Proposed Strategic Housing  
Development at St. Michaels Hospital Car  
Park

Stage 1 Surface Water Audit  
September 2020

Document Number: 202223-R0

**Appendix B      Site Layout with Stage 1 Audit Findings Highlighted**

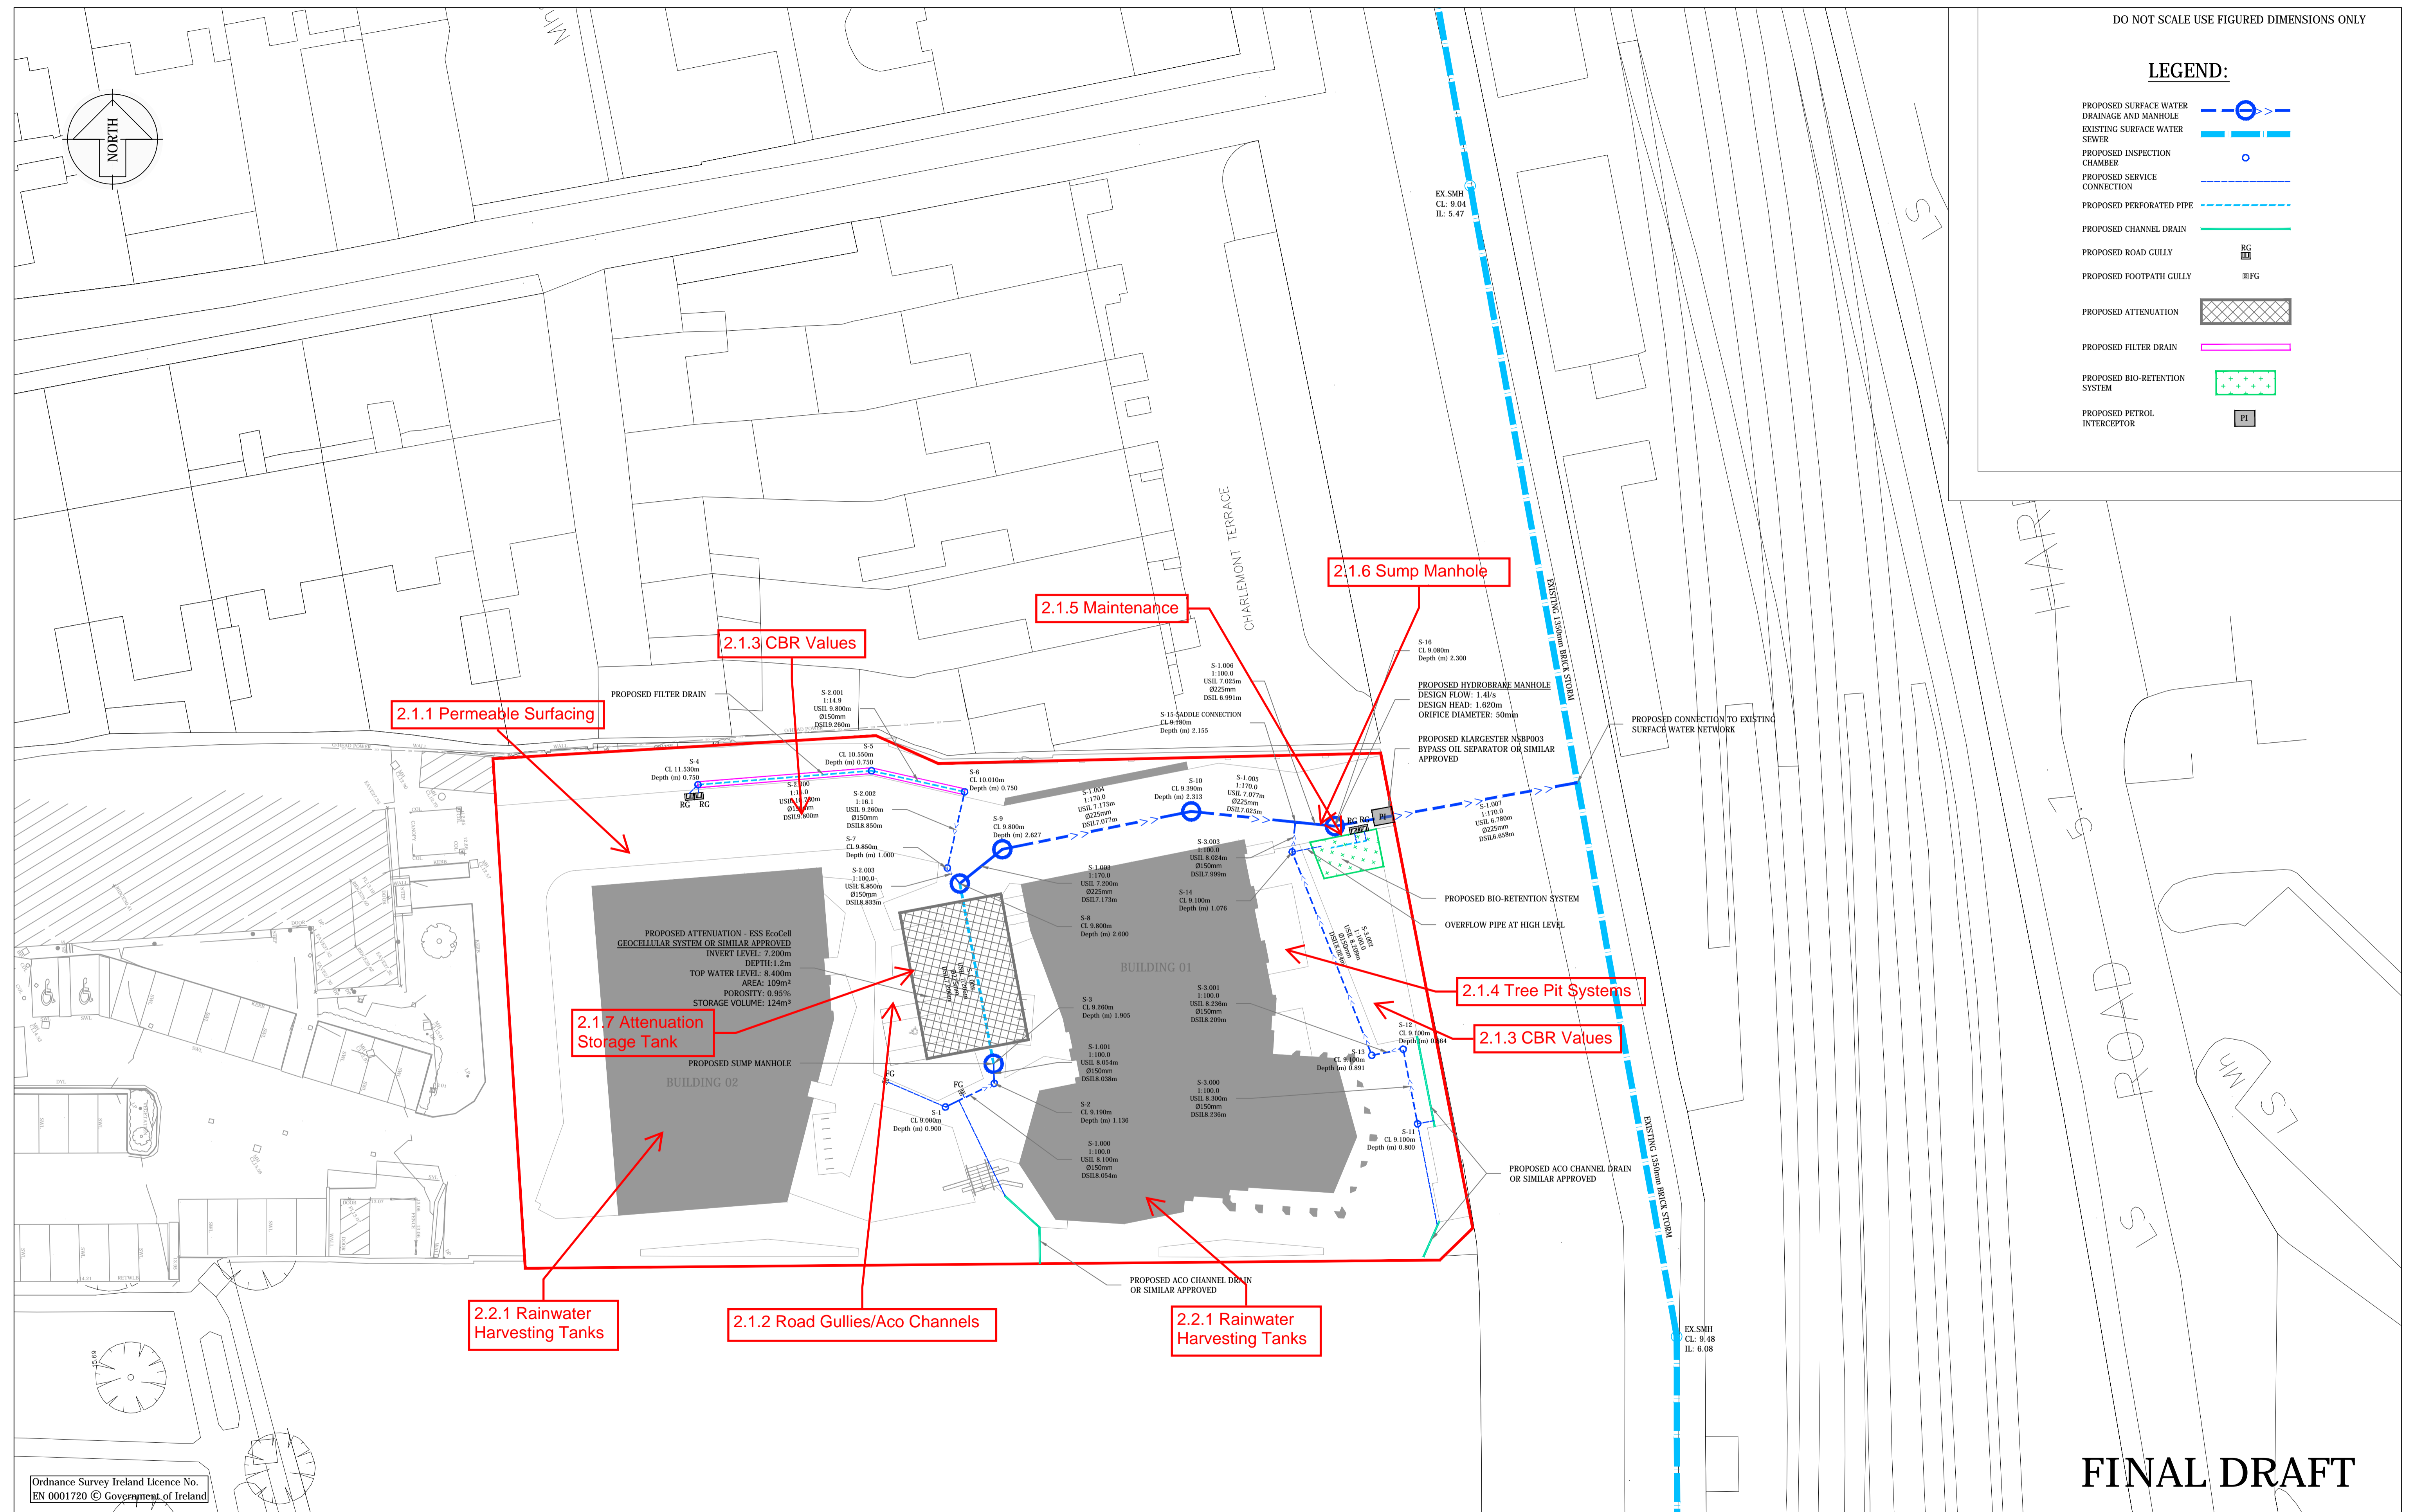
**Problem:** It is not clear on the drawings provided what surface is proposed for the proposed road and car parking spaces. Impermeable surfaces do not allow water to infiltrate to the ground.

**Recommendation:** Consider inclusion of permeable surfacing for the proposed road and car parking bays - such as permeable paving and porous asphalt. The stone layer within the build-up would have a dual effect of cleaning the surface water run-off contaminants, and attenuating the flow reducing the rate at which surface water would flow from the surface areas.

**Problem:** There is potential to further reduce the surface water runoff and to improve runoff quality from the roads around the development and parking bays by incorporating SuDS measures in lieu of road gullies.

**Recommendation:** In place of connecting the proposed gullies (not already connected to a Suds system) directly into the proposed surface water network, consider connecting proposed gullies to a SuDS measure such as tree pits, infiltration trench, bio retention area etc. with an overflow to the surface water network. This will further reduce the quantity and improve the quality of surface water runoff from the site.

**Problem:** Californian bearing ration (CBR) varies inversely with moisture content (as the latter increases the CBR value decreases). The equilibrium CBR value is the long-term value that occurs once the pavement is constructed and the moisture content of the subgrade soil comes in to equilibrium with the suction forces within the subgrade air spaces. Carrying out CBR tests will allow for appropriate permeable paving design including capping material if and where required. This capping is typically quite impermeable when compacted.

**Recommendation:** CBR tests to be performed on site to allow for appropriate permeable paving design. These CBR tests are to be carried out in accordance with BS 1377-4:1990.

**Problem:** There is potential to reduce the surface water runoff and to improve runoff quality from the development by providing a greater amount of SuDS measures in the form of tree pit systems.

**Recommendation:** Consider incorporating tree pit systems in areas in close proximity to the impermeable surfaces. Connect road gullies to these systems rather than directly to the main surface water drainage system.

**Problem:** The report makes reference to maintenance of green roofs but does not make reference to maintenance of the remaining SuDS measures on site.

**Recommendation:** Set out maintenance/inspection requirements for management of the surface water system. Maintenance management to include life-span of SuDS measures, inspection/monitoring details, grass and vegetation management, litter removal and excessive sediment removal.

Ensure there are a sufficient amount of inspection chambers/manholes specified for the proposed SuDS measures in order to achieve access for maintenance including rodding, etc.

**Problem:** Silt entering the system including the attenuation tanks has the potential to cause blockages.

**Recommendation:** Consider additional sump manholes to capture any excess silt therefore preventing entry into the attenuation tank.

**Problem:** There is potential to reduce surface water runoff from the development by incorporating an attenuation tank that allows for infiltration.

**Recommendation:** Consideration should be given to using attention tanks that permit water infiltration.

**Problem:** Where green roofs are not used, there is potential to install rainwater harvesting facilities for the proposed units which can be used for irrigation or for toilet flushing within the units.

**Recommendation:** Consider incorporating rainwater harvesting tanks.

Paragraph No. in Audit Report	Issue Accepted (Yes/No)	Recommended Measure Accepted (Yes/No)	Alternative Measures (described) [or reason problem not accepted]	Alternative Measures Accepted by Auditors (Yes/No)
2.1.1	Yes	Yes		
2.1.2	Yes	Yes		
2.1.3	Yes	Yes	The CBR tests will be undertaken before the detail design stage.	
2.1.4	Yes	Yes		
2.1.5	Yes	Yes		
2.1.6	Yes	Yes		
2.1.7	Yes	No	The proposed location of the underground attenuation tank is in between two building block of significant height. Given the anticipated foundations requirements it was deemed appropriate to propose a watertight underground attenuation storage design.

Paragraph No. in Audit Report	Issue Accepted (Yes/No)	Recommended Measure Accepted (Yes/No)	Alternative Measures (described) [or reason problem not accepted]	Alternative Measures Accepted by Auditors (Yes/No)
2.2.1	Yes	No	The Applicant has reservations in relation to providing rainwater harvesting systems as it is his experience that in the long term these systems become problematic given that they become a subject of an irregular maintenance.
